# UNITED STATES PATENT AND TRADEMARK OFFICE

APPLICATION NO.	FILING DATE	FIRST NAMED INVENTOR	ATTORNEY DOCKET NO.	CONFIRMATION NO.
10/585,652	04/29/2009	Arno Schubert	PF040001	5465
24498 7590 09/30/2010 Robert D. Shedd, Patent Operations THOMSON Licensing LLC P.O. Box 5312 Princeton, NJ 08543-5312			EXAMINER MAHONEY, CHRISTOPHER E	
			ART UNIT 2862	PAPER NUMBER
			MAIL DATE 09/30/2010	DELIVERY MODE PAPER

<b>Office Action Summary</b>	Application No. 10/585,652	Applicant(s) SCHUBERT ET AL.	
	Examiner Christopher E. Mahoney	Art Unit 2862

FIG. 10

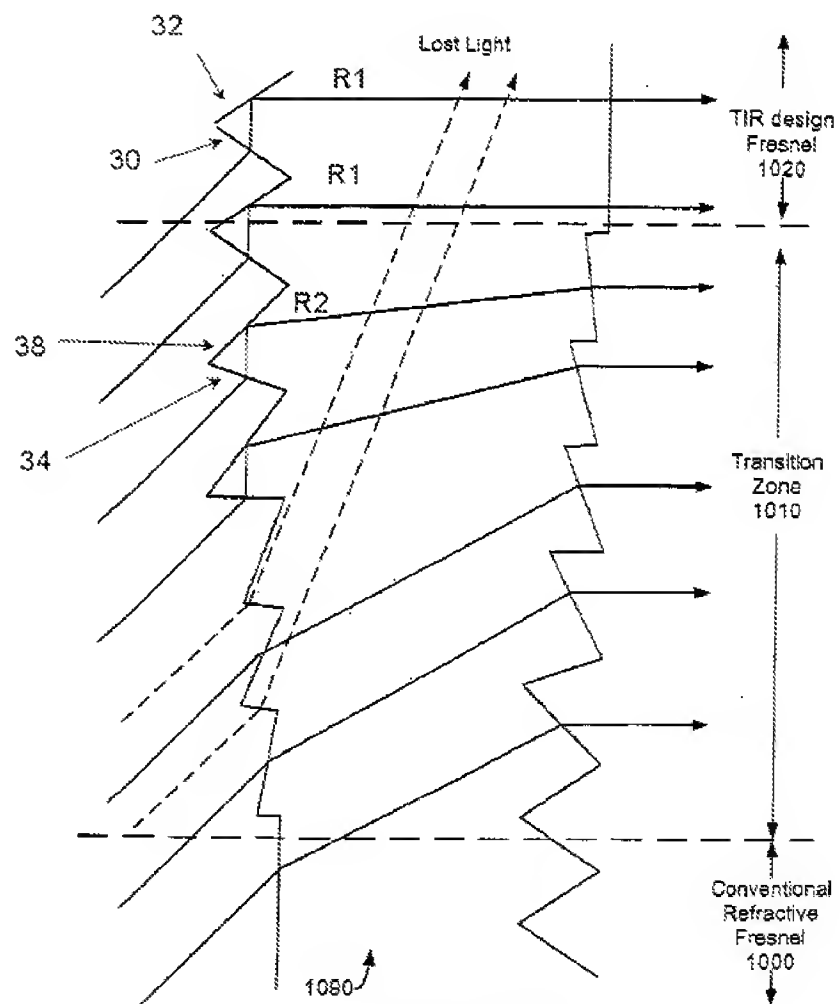
Claims 1-5, 8-10 and 14 are rejected under 35 U.S.C. 102(e) as being anticipated by Peterson (U.S. Pat. No. 7102820). Peterson teaches means of generating an image (DMD 350/1130); means of projecting the image (Lens system 340/1120) onto a screen (figs. 3, 11) the screen comprising a Fresnel lens (fig 10) said Fresnel lens including at least one first area comprising first prisms each first prism having a first side (30 annotated figure below) and a second side (32 annotated figure) which forms with a main axis an angle greater than that formed by the first side and the main axis AA, the second side of the first prism being designed to collimate (see R1 in annotated figure below), in line with the main axis an incident ray from said projection means, said Fresnel lens having symmetry of revolution about said main axis (circular Fresnel lens, also see fig. 6), wherein said Fresnel lens includes one second area comprising second prisms each second prism having a first side (34) and a second side (38) which forms with a main axis an angle greater than that formed by the first side and the main axis the second side of the second prism being designed to transmit, in a first direction (R2) different from the main axis an incident ray from said projection means.

While it is understood that the light exiting the Fresnel lens depicted in figure 10 ends up all collimated, the annotated figure below illustrates how the Peterson reference anticipates the claim language. R2 is divergent from the main axis.

Alternatively, the second prisms could be even lower (closer to the main axis) in the figure below. Regarding claims 9 and 10, if the second prisms are in the lower portion of Transition zone 1010, then the second prisms are working in a refractive mode.
